AMENDMENT TO THE DRAWINGS

The attached sheet of drawing, include changes to the sole Figure and replaces the drawing sheet as originally filed.

Fig. 1

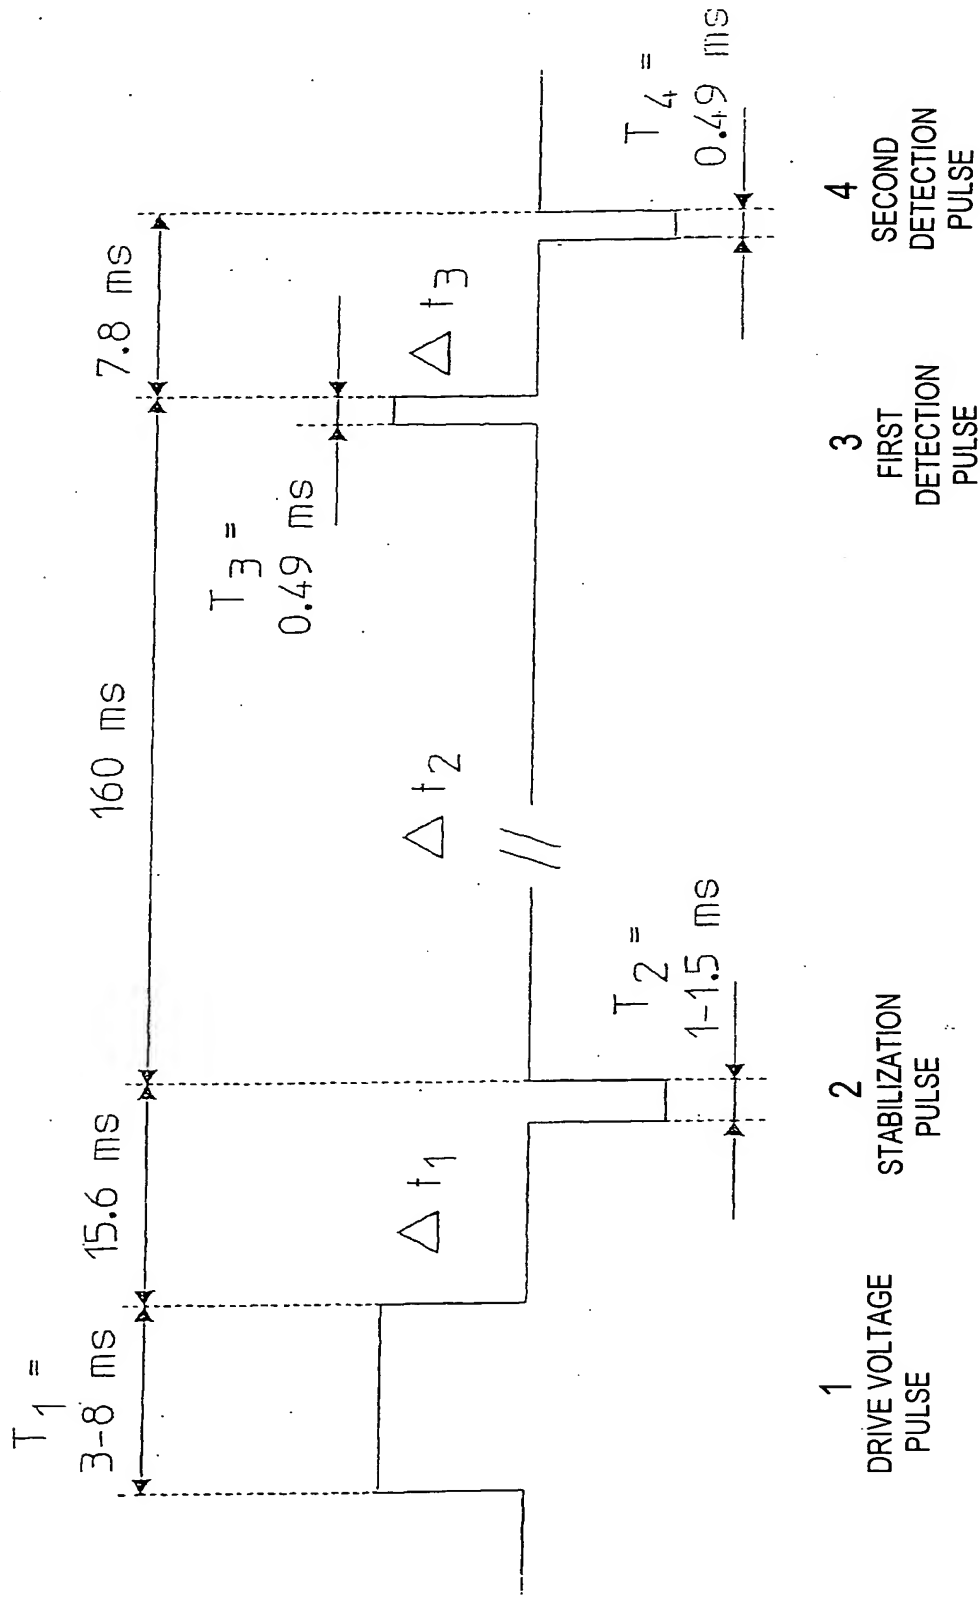
The designation of the 'voltage pulses' 1, 2, 3, 4 have been identified in the drawing.

The identity of the values of the drive voltage pulses 15,6 ms; 7,8; ms, etc., have been changed to – 15.6 ms, 7.8 ms, 0.49 ms, 1-1.5 ms, 0.4 ms. That is, the commas have been changed to periods.
